ADDENDUM NO. 4
TO THE CONTRACT DOCUMENTS
for the construction of the
NAMPA WWTP PHASE I UPGRADES:
GROUP A—LIQUID STREAM UPGRADES

Date: March 6, 2015
Project No.: 480770

The following changes, additions, and/or deletions are hereby made a part of the Contract Documents for the construction of the Nampa WWTP Phase I Upgrades: Group A—Liquid Stream Upgrades, dated December 2014, as fully and completely as if the same were fully set forth therein:

HOIST/MONORAIL DIMENSION SHEET
Building Clearances for Monorail Cranes

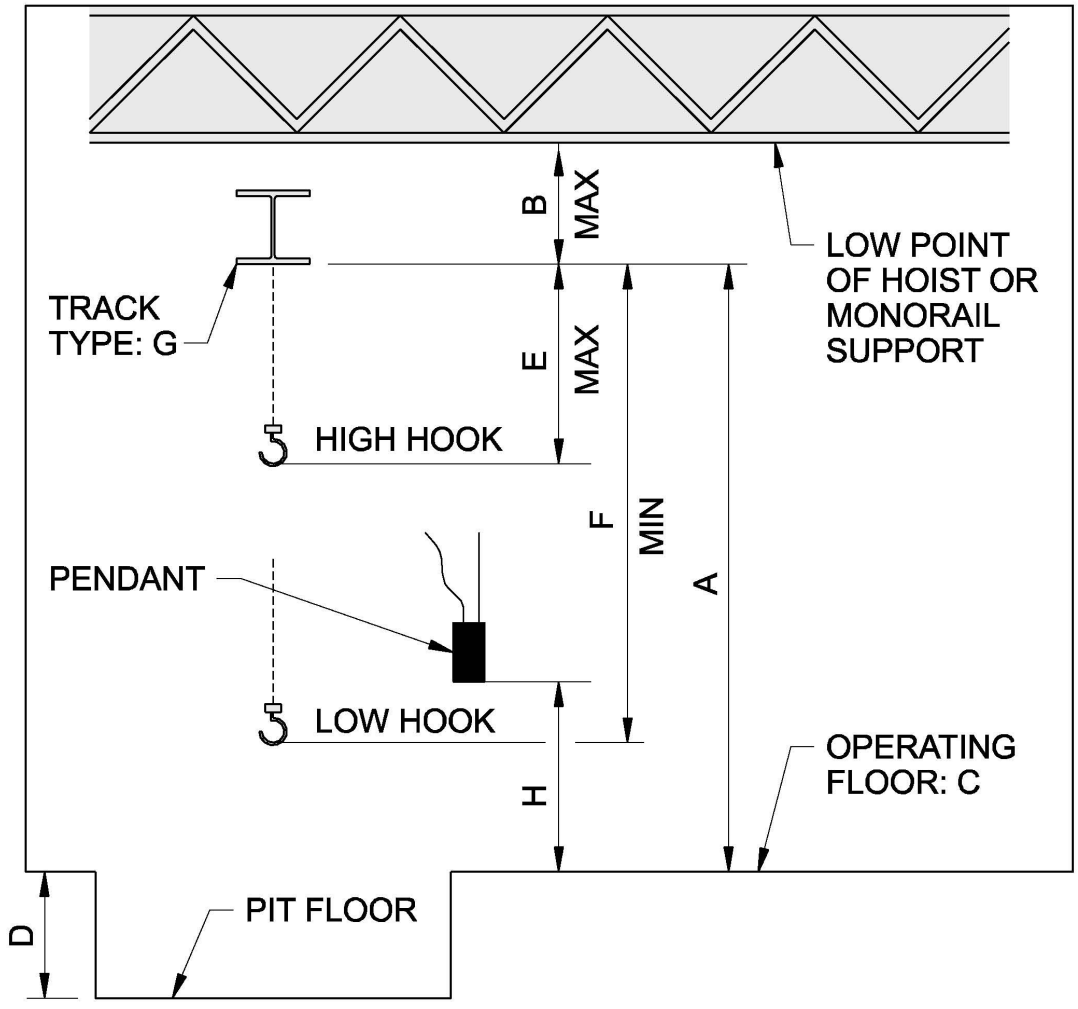
6. Section 41 22 23.19, Monorail Hoists¹: ADD in its entirety.

AS NOTED
VERIFY SCALE
BAR IS ONE INCH ON ORIGINAL DRAWING.
DATE DECEMBER 2014
PROJ 480770
DWG 050-D-108
SHEET 26 of 157

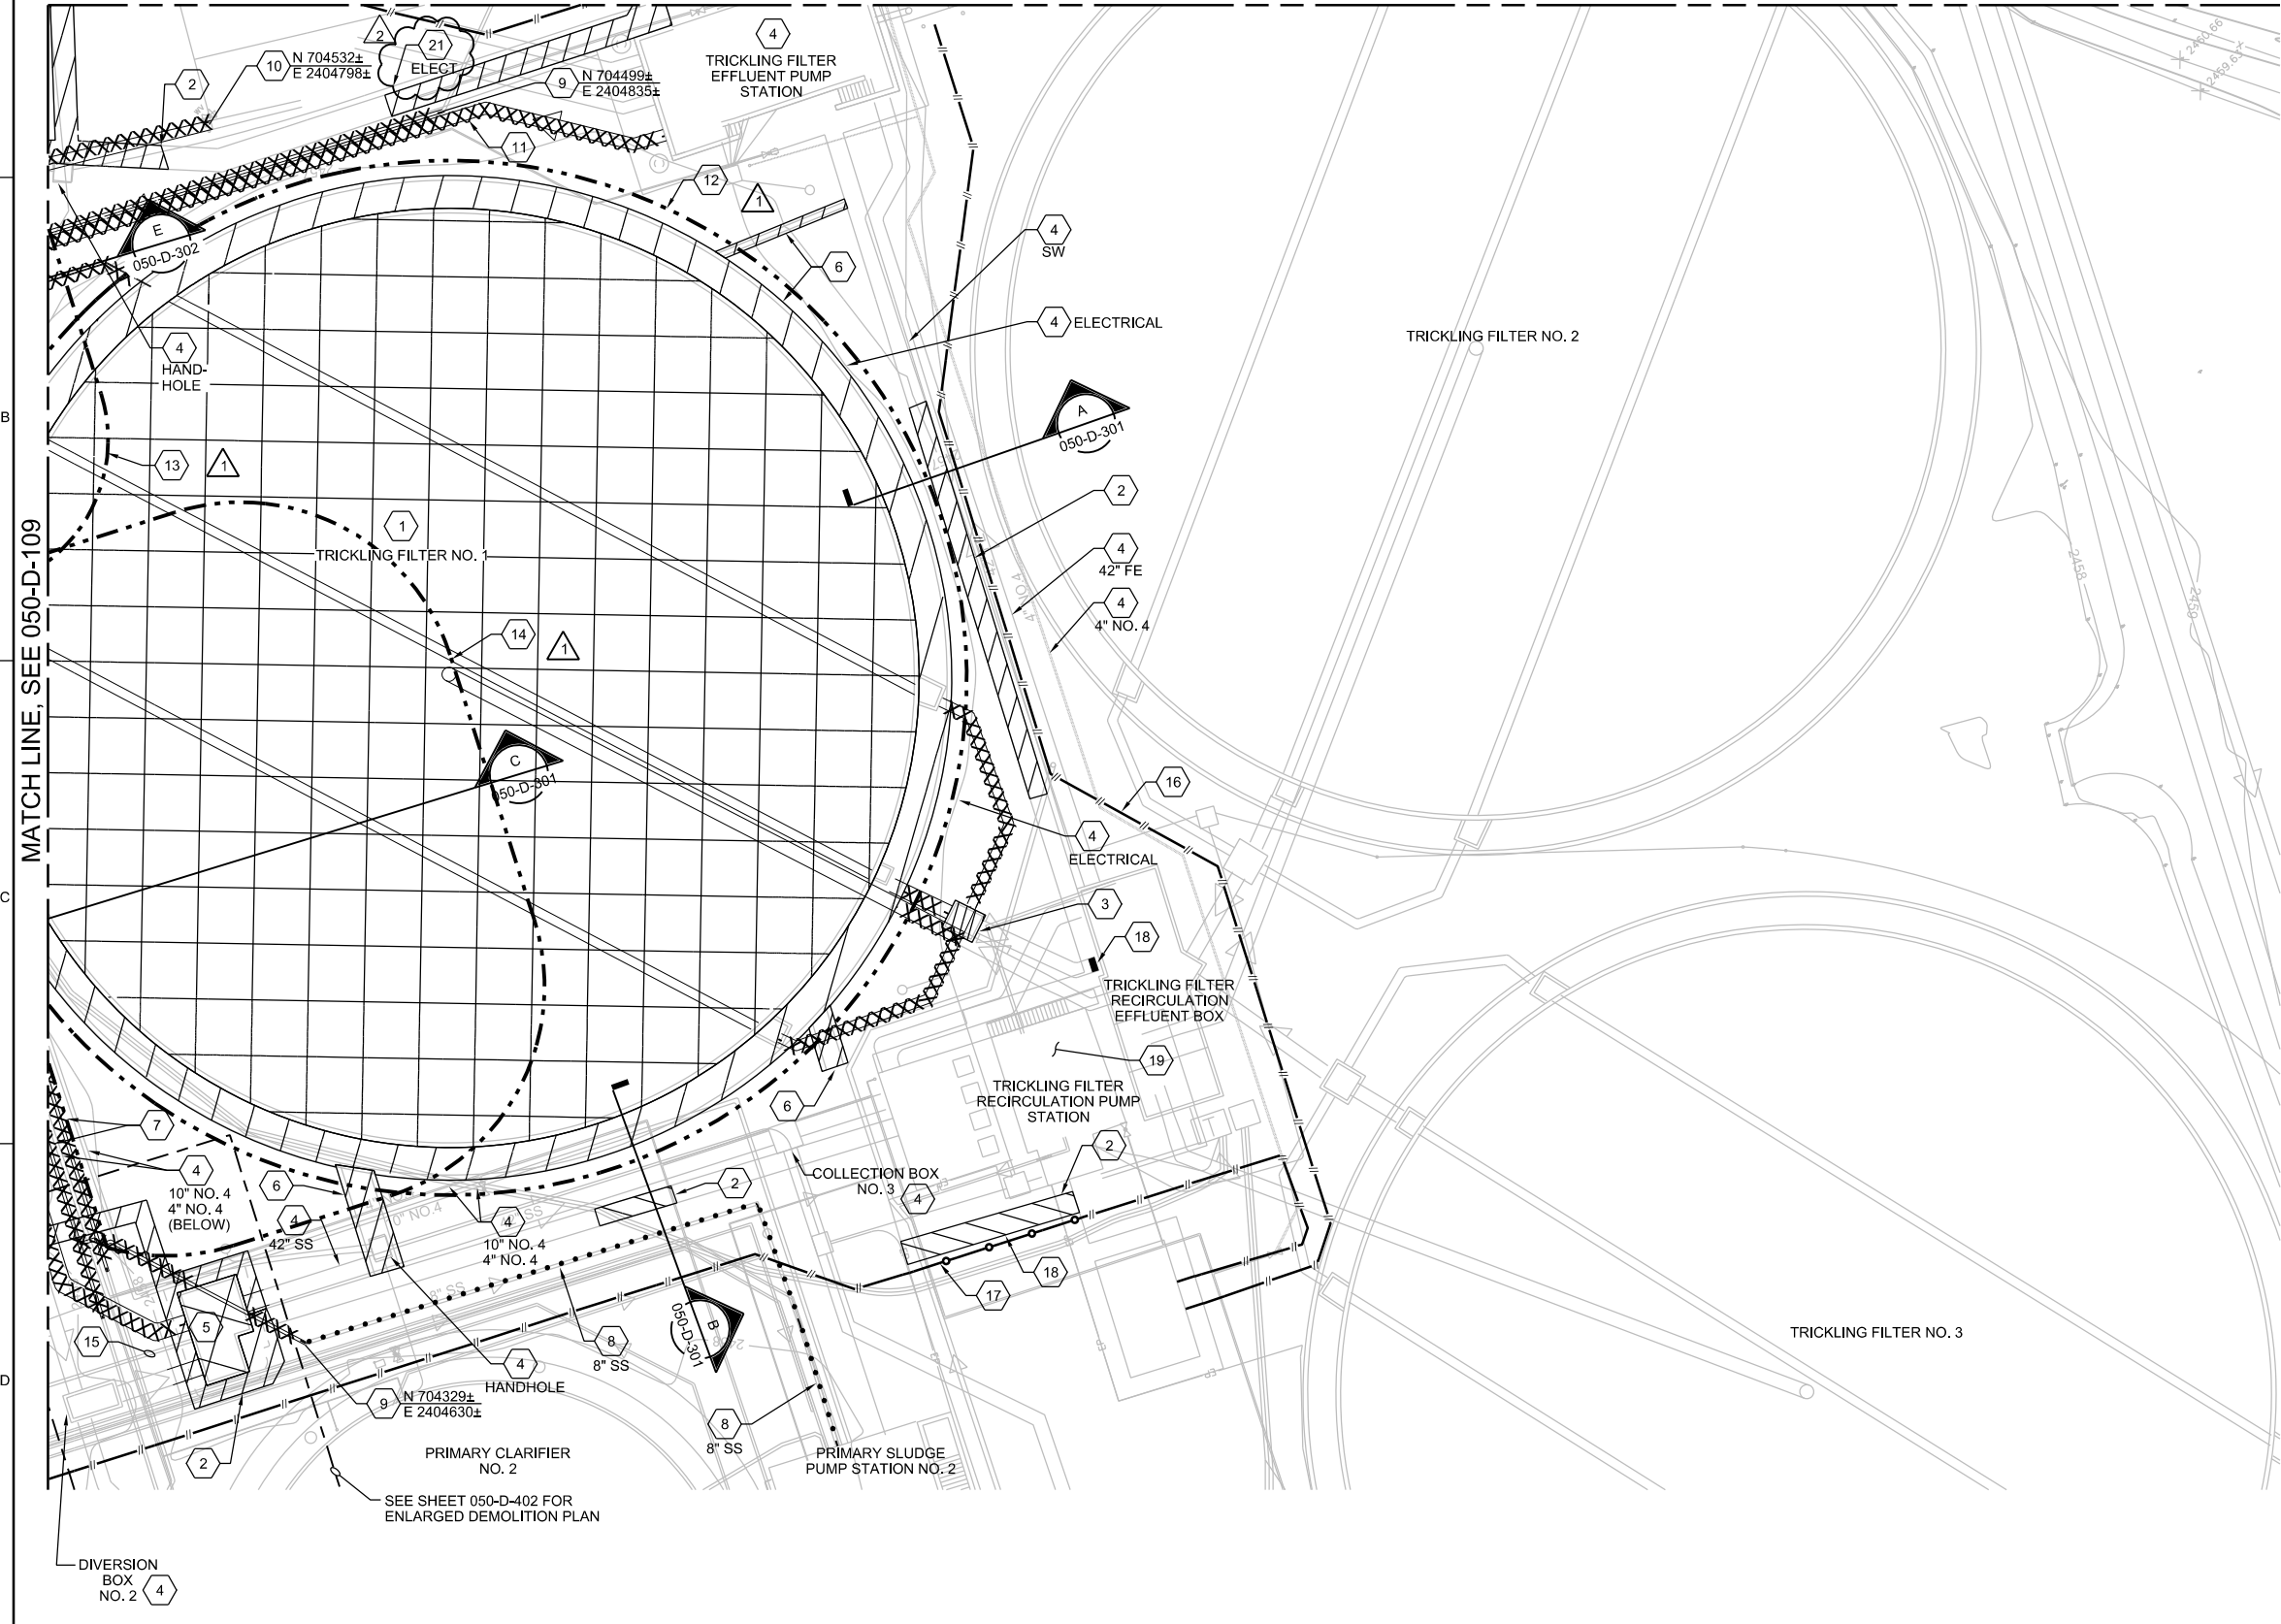
1. Drawing 010-G-025: Under the REMARKS column for service Air, Low Pressure, ADD “STEEL PIPE FOR AIR LOW PRESSURE SERVICE SHALL BE UNLINED.”
2. Drawing 050-D-108²: REPLACE drawing in its entirety.
3. Drawing 050-D-109³: REPLACE drawing in its entirety.

4. Drawing 050-D-113: REPLACE Keynote 4 on Drawing 050-D-113 with the following text: “MAINTAIN POWER TO AND CONTROLS TO SECONDARY CLARIFIER NO. 2 DRIVE AND WALKWAY LIGHTS FROM THE ADMIN BUILDING THROUGHOUT CONSTRUCTION. IT IS ANTICIPATED THAT THE CURRENT CIRCUIT WILL BE DISRUPTED BY THE CONSTRUCTION OF AERATION BASIN 3. PROVIDE TEMPORARY WIRING AND WATER PROOF SPLICING AS REQUIRED TO ACHIEVE CONSTRUCTION SEQUENCE. RESTORE EXISTING CIRCUITS TO ORIGINAL FUNCTIONALITY, USING EXISTING CONDUCTORS AND RACEWAYS WHEN POSSIBLE. REPLACE DEMOLISHED CONDUITS AND CONDUCTORS WHERE REQUIRED. PROVIDE WATERPROOF SPLICES IN HANDHOLES WHERE SPLICES ARE REQUIRED. ASSUME SECONDARY CLARIFIER CIRCUITS INCLUDE [1"C-2#12, 1#12G (LIGHTING)], [1"C-3#12,6#14, 1#10G(CLARIFIER)], [1"C SPARE].”

21. MAINTAIN NETWORK COMMUNICATIONS TO TRICKLING FILTER EFFLUENT PUMP STATION FROM ADMIN BUILDING. IT IS ANTICIPATED THAT THE CURRENT CIRCUIT WILL BE DISRUPTED BY THE CONSTRUCTION OF AERATION BASIN 3. PROVIDE TEMPORARY WIRING AS REQUIRED TO ACHIEVE CONSTRUCTION SEQUENCE. RESTORE EXISTING CIRCUIT TO ORIGINAL FUNCTIONALITY, USING EXISTING RACEWAYS WHEN POSSIBLE. REPLACE DEMOLISHED CONDUITS AS REQUIRED. REPLACE EXISTING CABLE WITH A NEW CABLE. CABLE SPLICING IS NOT ACCEPTABLE. NEW NETWORK CABLE SHALL BE [1" C-1 TYPE 3].

AS NOTED
VERIFY SCALE
BAR IS ONE INCH ON ORIGINAL DRAWING.
DATE DECEMBER 2014
PROJ 480770
DWG 050-E-103
SHEET 53 of 157

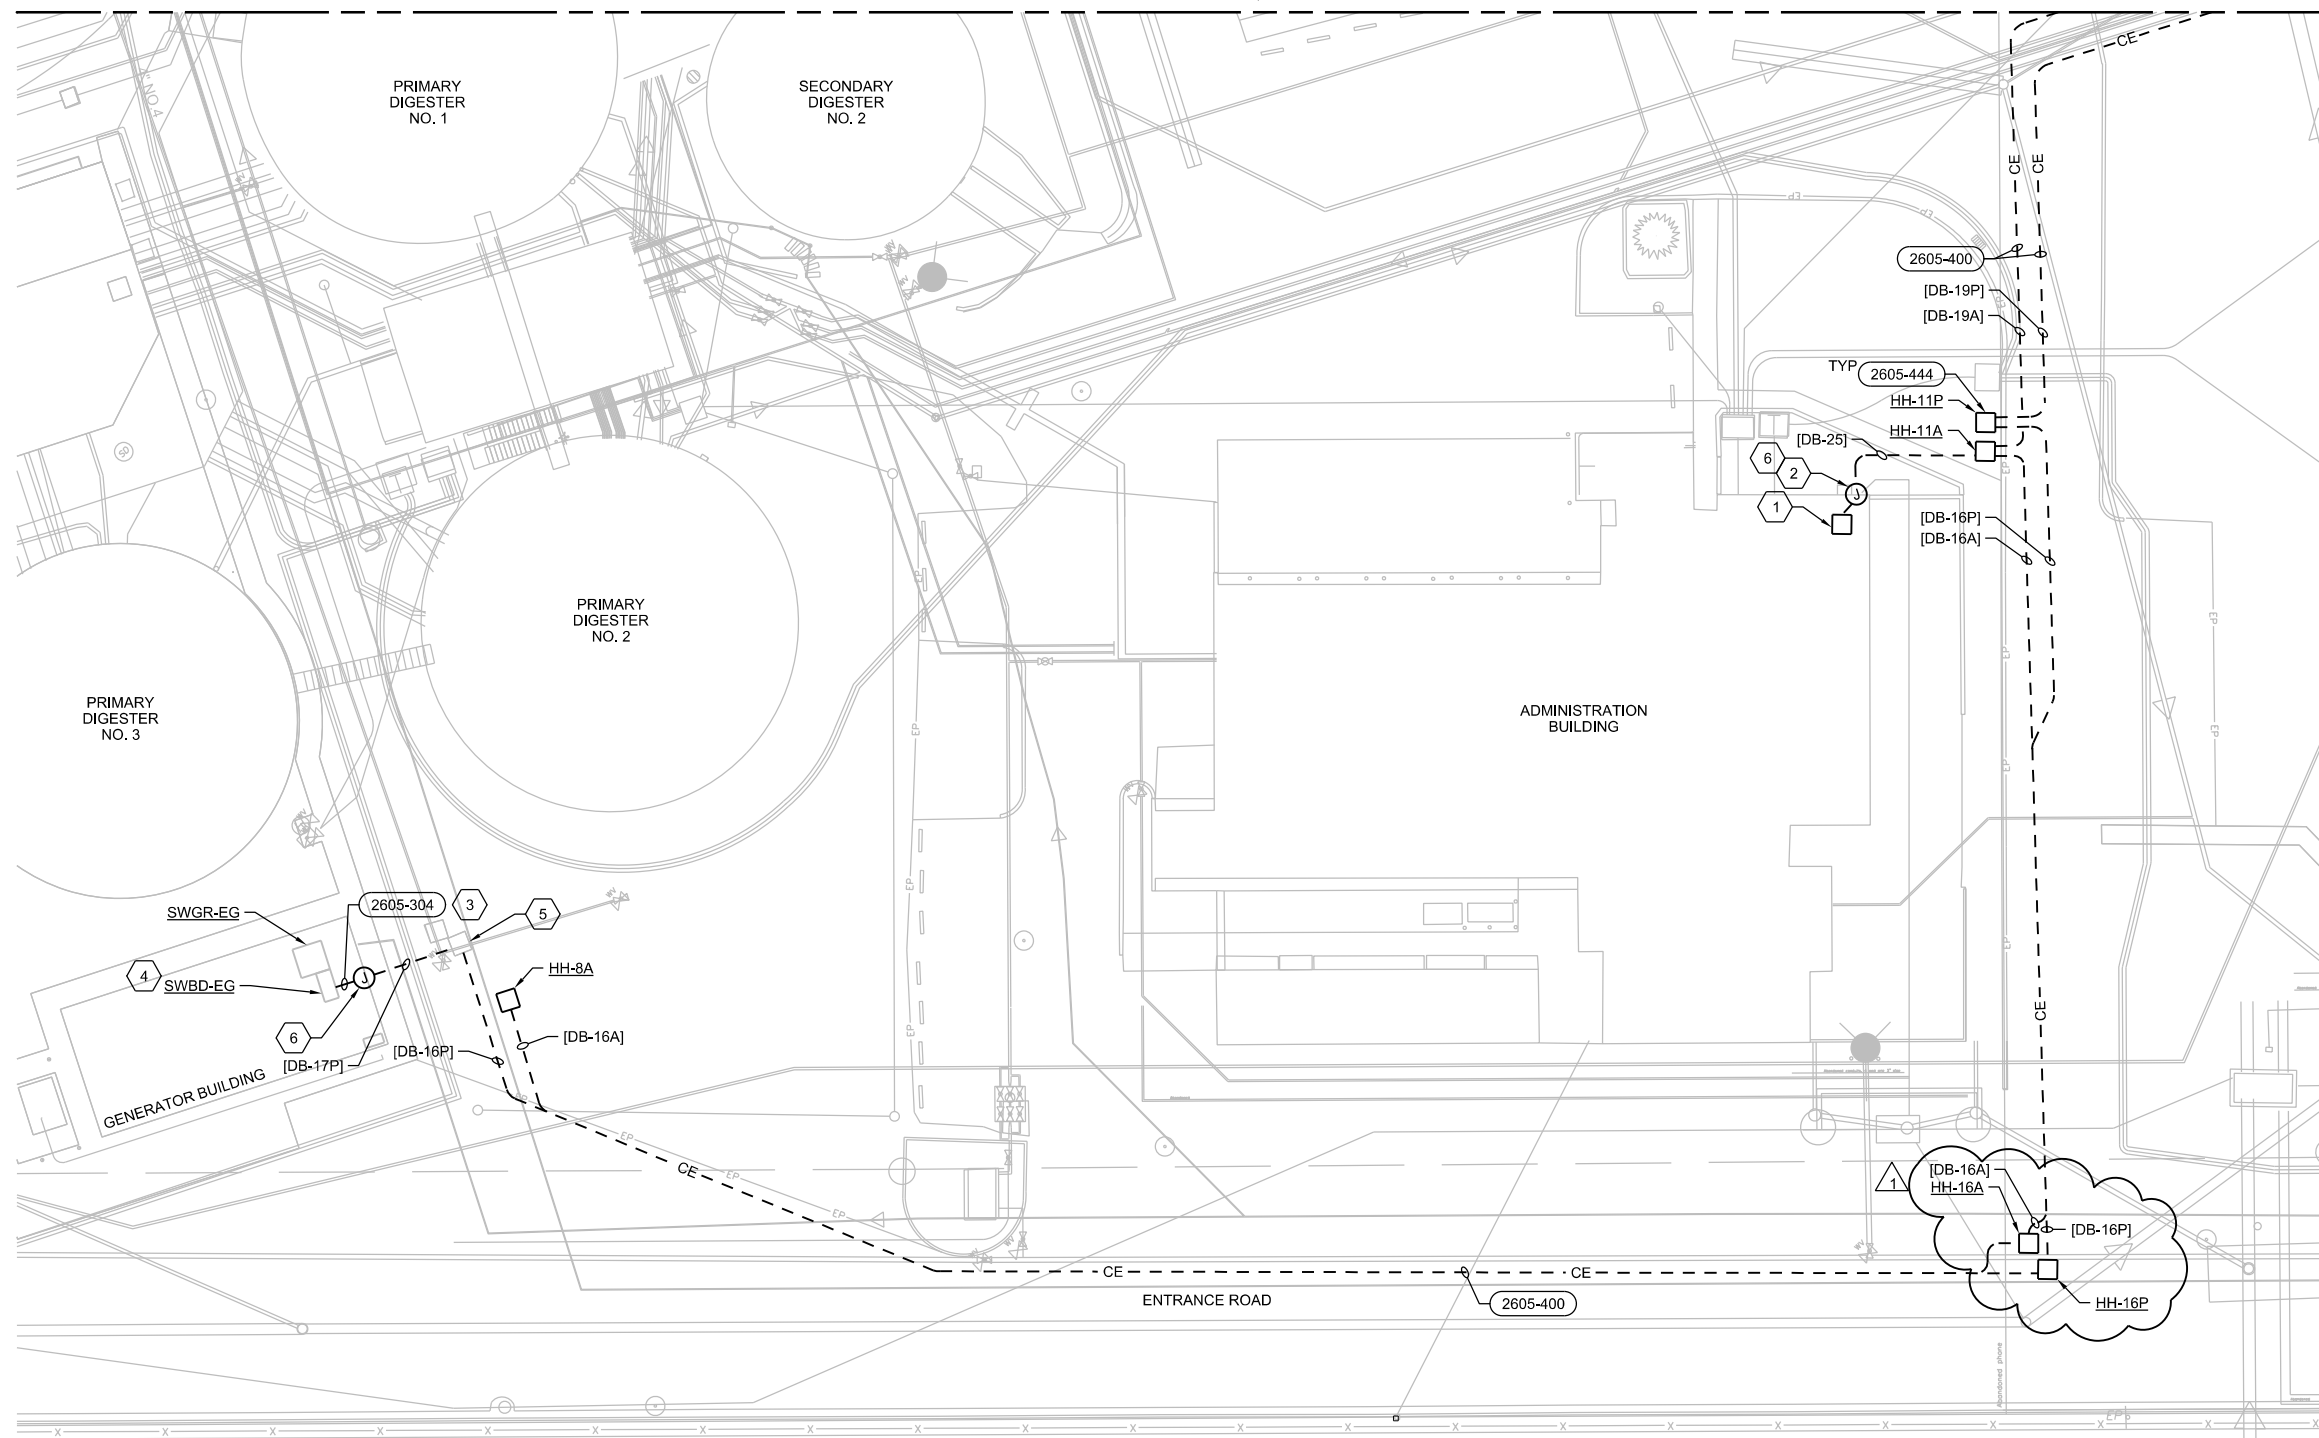
10. Drawing 050-E-103⁵: REPLACE Drawing 050-E-103 with the attached drawing.
11. Drawing 050-E-108⁶: REPLACE drawing in its entirety.
12. Drawing 050-E-109⁷: REPLACE drawing in its entirety.
